Sundry ID: 2664826

Type of Action: Plug and Abandonment

Plug and Abandonment Procedure
for
DJR Operating, LLC
Jicarilla Apache B 20
API # 30-039-27721
NE/NE, Unit A, Sec. 19, T24N, R5W
Rio Arriba County, NM

Attachment to notice of Intention to Abandon

DJR Operating, LLC
Proposed Wellbore Diagram
Jicarilla Apache B 20
 API # 30-039-27721
 NE/NE, Unit A, Sec 19, T24N, R5W
 Rio Arriba County, NM

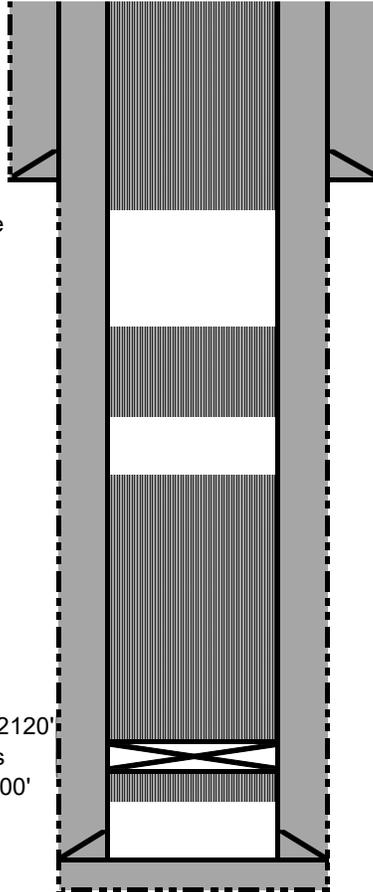
You are also required to place cement excesses per 4.2 and 4.4 of the attached General Requirements.
